Service Bulletin

Bulletin No.: 21-NA-212

Subject: Information on Power Front Seat Adjuster Track Service Part Availability Separate from Complete Seat Cushion Frame Assembly

5902829

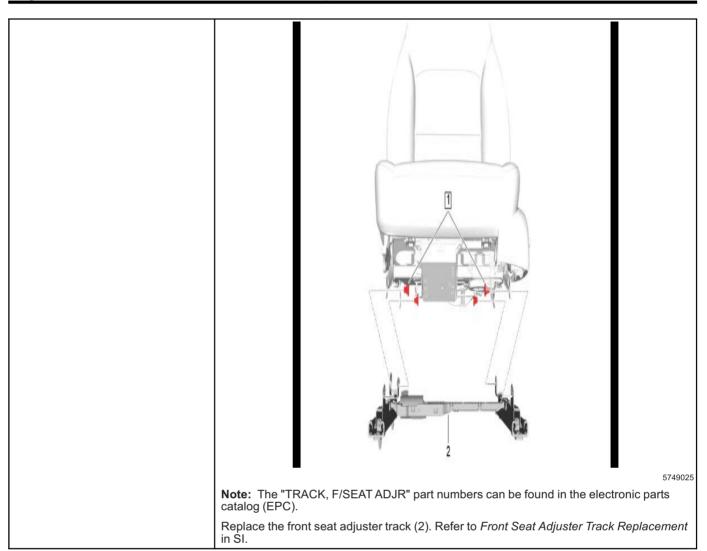
Involved Region or Country	North America, Chile, Europe, Israel, Middle East, Egypt, GM Korea Company, Cadillac Korea (South Korea)
Information	If there are issues with fore/aft movement, binding or other conditions of the power front seat adjuster track, and the diagnosis leads to front seat adjuster track replacement, the front seat adjuster track has been released as a service part (no longer serviced by the complete seat cushion frame assembly).

Note: Do not replace the complete seat cushion frame assembly for a seat track movement condition.

Caution: To remove the new power front seat adjuster track from the shipping container, lift it up with one hand on each track. Do not lift the power front seat adjuster track by holding the bridge; it may cause damage to the material.
